## **City of Ryde Submission**

**Ryde Hospital Stage 2 - SSD-58210458  
1 Denistone Road Eastwood**

**Submission Date: 13 December 2023  
COR2023/89/1**

**Figure 1: Approved building Envelope and proposed Height**

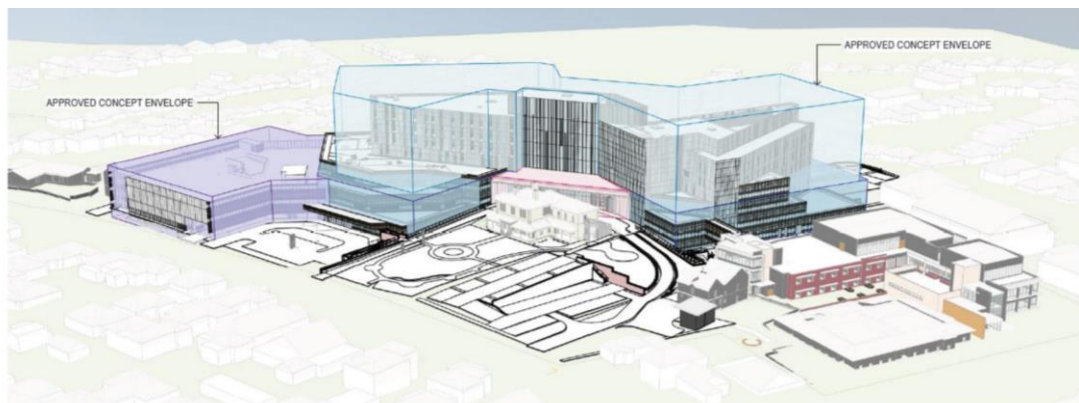
It seems that the new building is not in line with building envelope as approved in the Concept Approval. Page 57 of the EIS states that the podium will exceed the envelope near Denistone House and refers to it as a minor protrusion. However, no details have been provided to demonstrate the extent of this breach and how it may impact on the Denistone House. Details provided in Figure 28 (refer to Figure 1 below) in the EIS does not show any details of height protrusion.

The EIA claims the need is for raised structural slab have resulted in the exceeded height of the podium near the Denistone House. There is no evaluation as to why there is no greater impact on heritage building resulting from changed building envelope. In addition, there is no details of heritage consultants input to the design change.

- Details of the protrusion beyond the building envelope to be provided and evaluated by the heritage consultant and addressed in HIS.
  - Provide clear labels and dimensions on the plans and demonstrate the extent of protrusion and impact emanating from that.
- b. **Condition C6 – Landscaping.** This condition requires all future development application(s) to include a landscape report and plans, prepared by a suitably qualified professional, including the detailed design and treatment of all ground and above ground surface areas on the site and within the adjoining public domain. The landscape plans must be designed having regard to the relevant matters outlined in conditions C3, C4 and C5 of Schedule 2. In this regard the following issues are highlighted:

**Figure 2: Vertical travel marked adjacent to Denistone House**

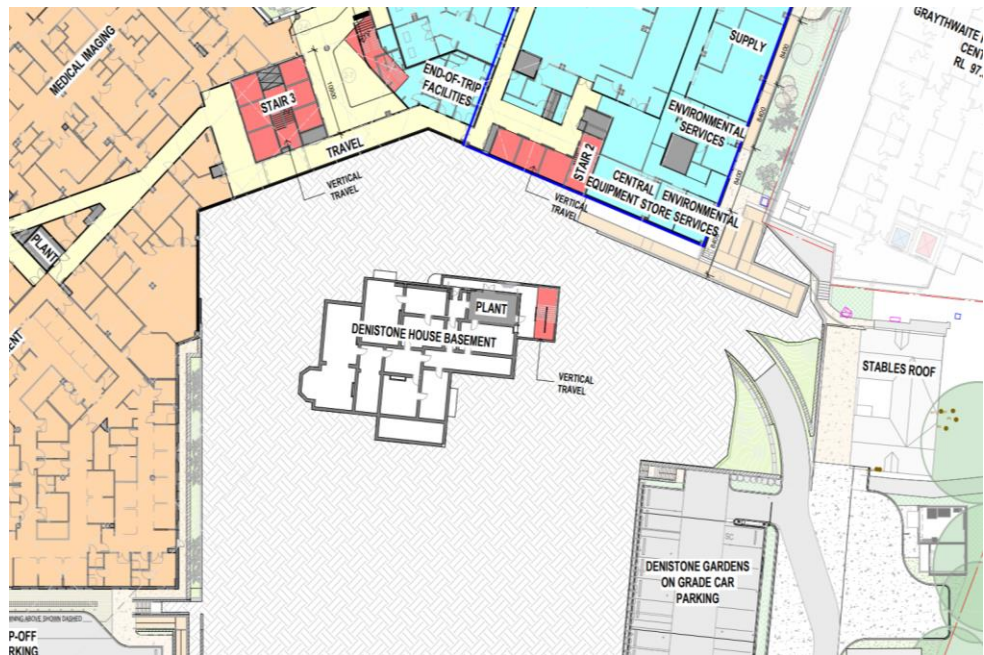
- Concern is also raised about the design details relating to garden area behind the at-grade carpark and to north of the Denistone House. It shows a 'vertical travel' and sketches imply grade separation
